INVITATION TO TENDER "ITT" NO. PS20180020
CONTRACTOR FOR ROOF AND SKYLIGHT REPLACEMENT AT
CHAMPLAIN HEIGHTS COMMUNITY CENTRE

ADDENDUM NO. 2

Pitched Roof and Skylight Replacement

Champlain Heights Community Centre
3350 Maquinna Drive, Vancouver, BC

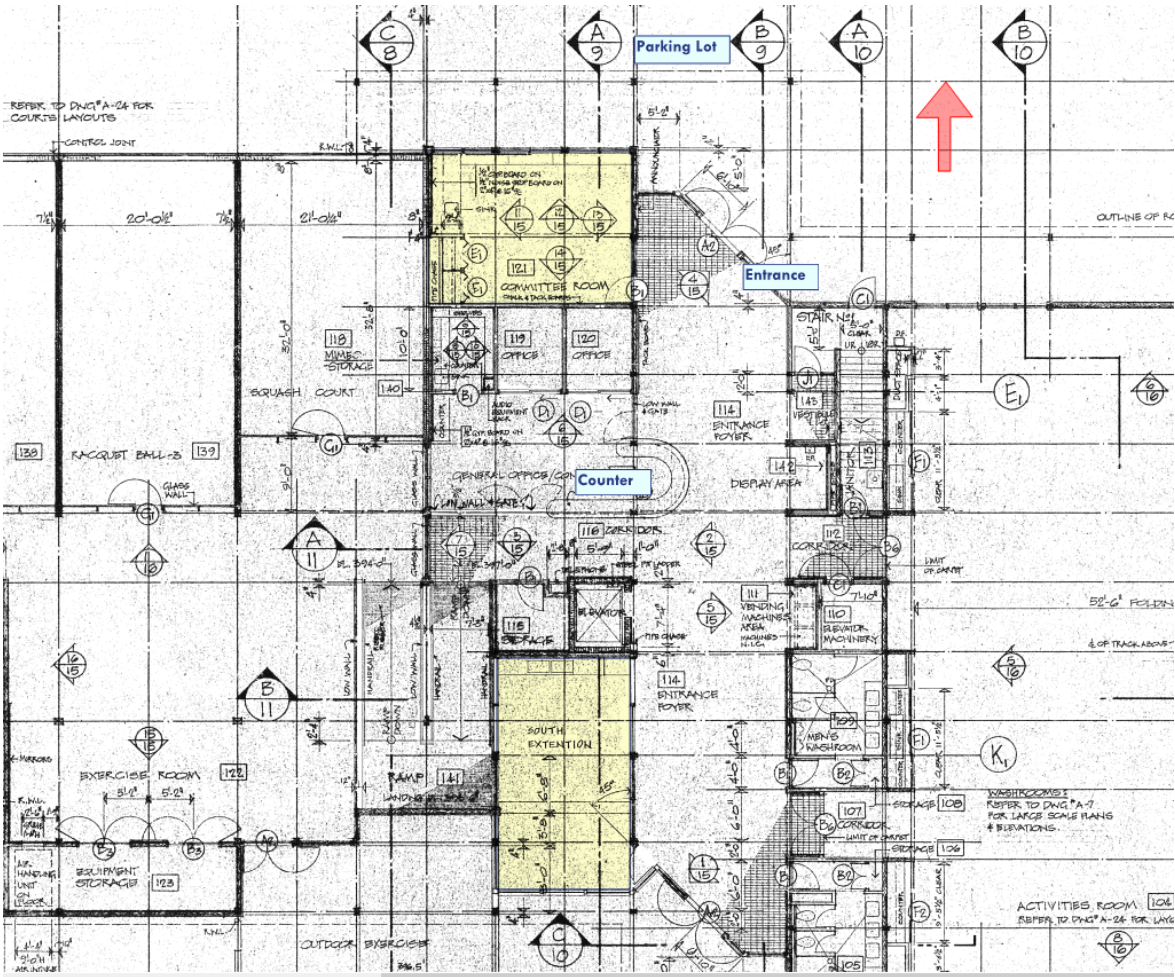
- .3 The two rooms identified in the attached floor plan are used as daycare facilities during the summer and areas of work above these rooms are to be highest priority for completing the work. The Contractor shall complete the majority of their work in these areas prior to July 4th, 2018. Beginning on July 4th, the hours of work within these spaces will be limited to before 10:00AM and after 3:00PM. The spaces will not be used on Saturdays and construction may proceed above these areas on Saturdays, subject to Vancouver By-Law restrictions.
